Proposal for Supplement 5 to the 01 Series of Amendments to UN Regulation No. 149 (Uniform provisions concerning the approval of road illumination devices (lamps) and systems for power-driven vehicles)

The text reproduced below was prepared by the expert from The Netherlands on behalf of the I WVTA IWG to delete the Unique Identifier (UI) marking provisions. The modifications to the existing text are marked in bold for new and strikethrough for deleted characters.

FIGURE I – UNIQUE IDENTIFIER (UI)

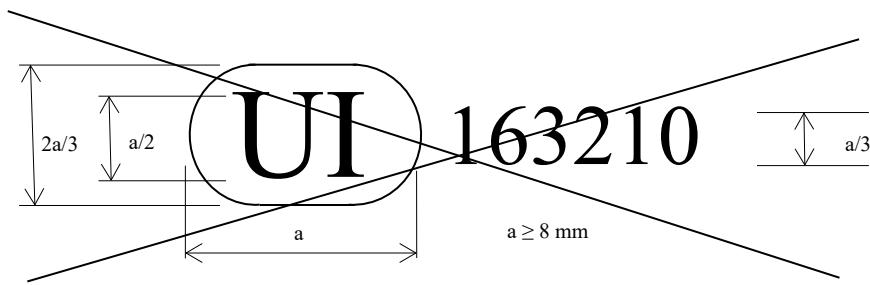
3.3.3. ~~The approval marking as defined in paragraph 3.3.2. may be replaced by the Unique Identifier, if available. The Unique Identifier mark shall follow the format in the example shown below~~

The above Unique Identifier marked on the lamp shows that the type concerned has been approved and that the relevant information on that type approval can be accessed on the UN secure internet database by using 163210 as the Unique Identifier.
